DOMINION NUCLEAR CONNECTICUT, INC.
MILLSTONE POWER STATION UNITS 2 AND 3
MARCH 12, 2012 COMMISSION ORDER MODIFYING LICENSES WITH REGARD TO
REQUIREMENTS FOR RELIABLE SPENT FUEL POOL INSTRUMENTATION
(ORDER NUMBER EA-12-051)
RESPONSE TO REQUEST FOR ADDITIONAL INFORMATION (RAI)

Response to Request for Additional Information
Reliable Spent Fuel Pool Instrumentation

Millstone Power Station Units 2 & 3
Dominion Nuclear Connecticut, Inc. (DNC)

MPS3 SFP Elevations

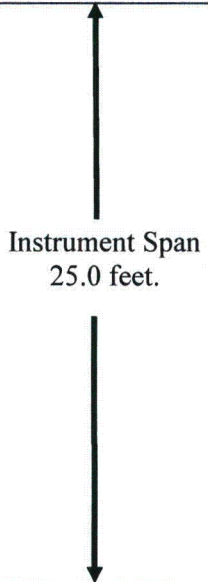
- a) The specific functional reasons for identification of the elevations within the SFP as levels 1, 2 and 3. For level 1, specify how the identified location represents the HIGHER of the two points described in the NEI 12-02 guidance for this level.
- b) A clearly labeled sketch depicting the elevation view of the proposed typical mounting arrangement for the portions of instrument channel consisting of permanent measurement channel equipment (e.g., fixed level sensors and/or stilling wells, and mounting brackets). Indicate on this sketch the datum values representing Level 1, Level 2, and Level 3 as well as the top of the fuel. Indicate on this sketch the portion of the level sensor measurement range that is sensitive to measurement of the fuel pool level, with respect to the Level 1, Level 2, and Level 3 datum points.

- b) The table below provides an elevation view of the MPS3 SFP showing the proposed Level 1, 2, and 3 values and elevations of the fuel racks and cooling system. The final determination of Level 3 will take into account the weight located on the bottom end of the probe (refer to RAI Response 3b). The final mounting arrangement (e.g., fixed level sensors and mounting brackets) will be available upon completion of the final design, scheduled for December 2013, and will be forwarded to the NRC during the subsequent scheduled status update.

Location	Absolute Elevation above MSL (ft.)		
Top of SFP Wall	52.3		
Top of Instrument Span	50.3		
Nominal Level	49.8		 <p>Instrument Span 25.0 feet.</p>
LEVEL 1 * - Top of Cooling Suction Inlet Pipe	46.8		
LEVEL 2	35.3		
Top of Fuel Racks + 10 feet	35.1		
Centerline of cooling pumps	26.6	 <p>10 ft.</p>	
LEVEL 3 - Bottom of Instrument Span	25.3		
Top of Fuel Racks	25.1		
		 <p>13.8 ft.</p>	
Bottom of Pool	11.3
